## Memorandum

To: Anne Hersch, City of Albany  
From: Christy O'Berry  
Reviewed by: Jonathan L. Kramer  
Date: January 4, 2012  
RE: PA08-038 (AT&T Mobility)  
1035 San Pablo Ave

At the direction of the City, I have reviewed the AT&T Mobility ("AT&T") application to install a new wireless telecommunications facility on the roof of the commercial building located at 1035 San Pablo Ave. Sprint is also located at this site, and on the same roof.

Figure I: Existing AT&T signal coverage in the Cellular band without the proposed site, all as asserted by AT&T. (Source: AT&T Mobility).

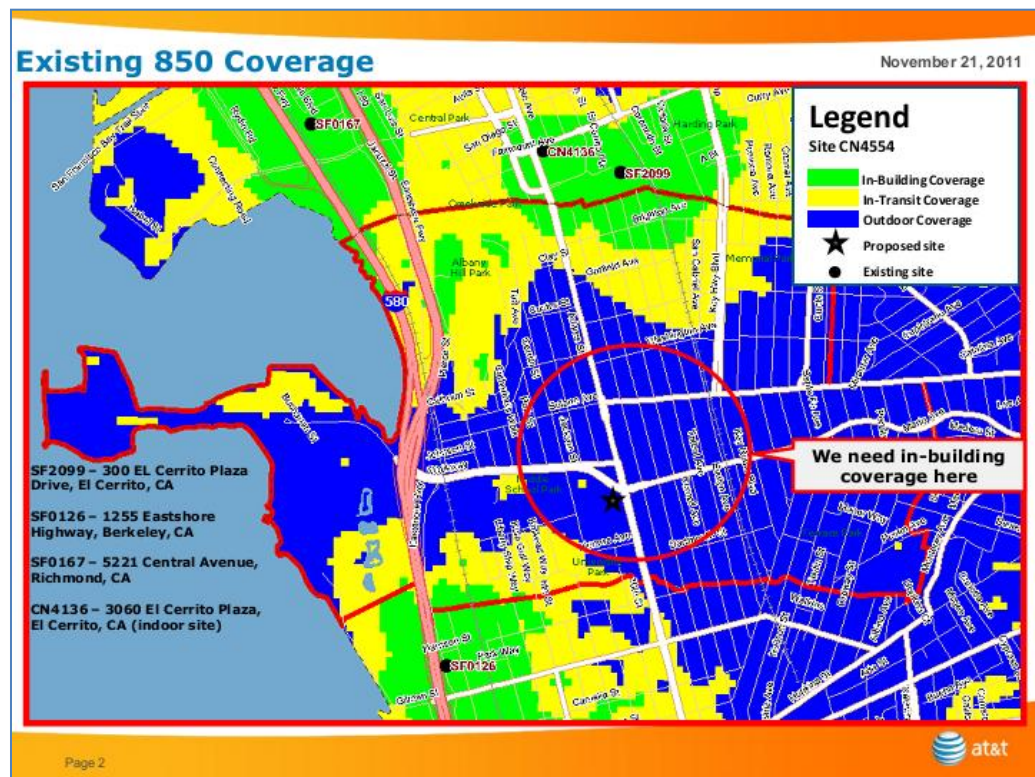
Figure I below, depicts AT&T's computer projection assertions of the existing coverage levels in only the Cellular band for the area surrounding the proposed site. The coverage map indicates that AT&T currently has "outdoor" signal level coverage, as AT&T defines that term, to the areas surrounding the proposed site.

The coverage maps and project documentation support the proposition that AT&T is attempting to improve its service in the Cellular band to southeast Albany and indicates that AT&T has a lower grade of existing coverage in its Cellular band of service this area, whatever that grade may be.

**Figure 2:** Proposed AT&T signal coverage in the Cellular band with the proposed site operational, all as asserted by AT&T. (Source: AT&T Mobility).

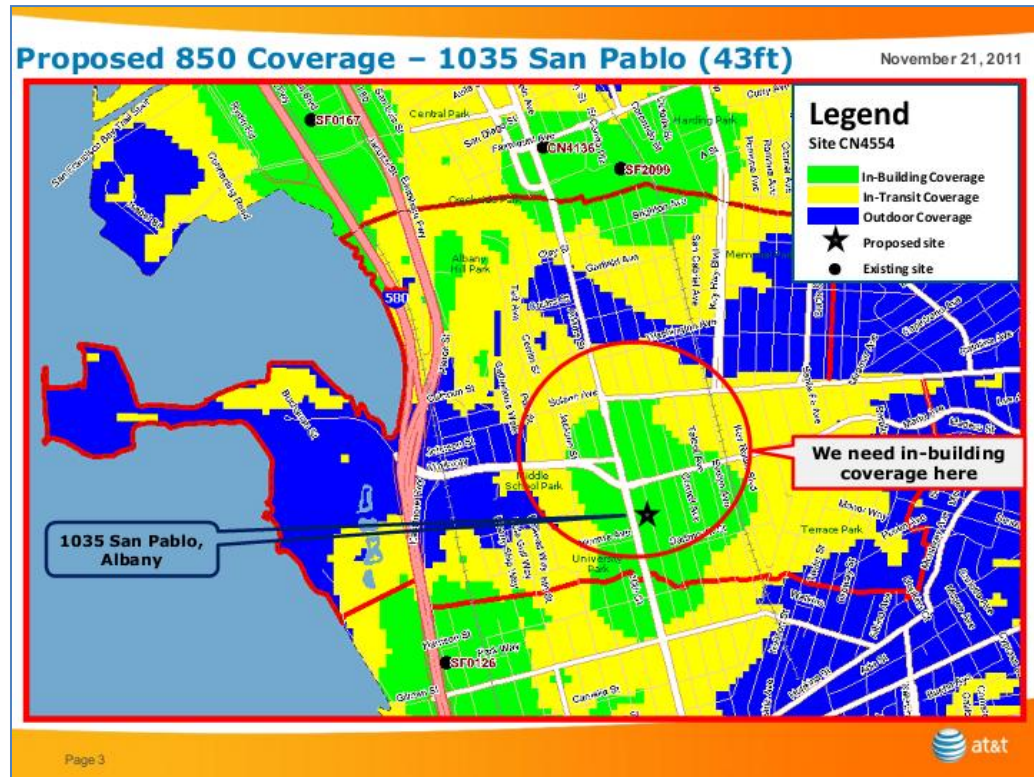
Figure 2 above, indicates that the proposed site will provide “in-building” signal coverage, as AT&T defines that term, to the area surrounding the site in the Cellular band of service, and “in-transit” (mobile) coverage beyond the “in-building” coverage area.
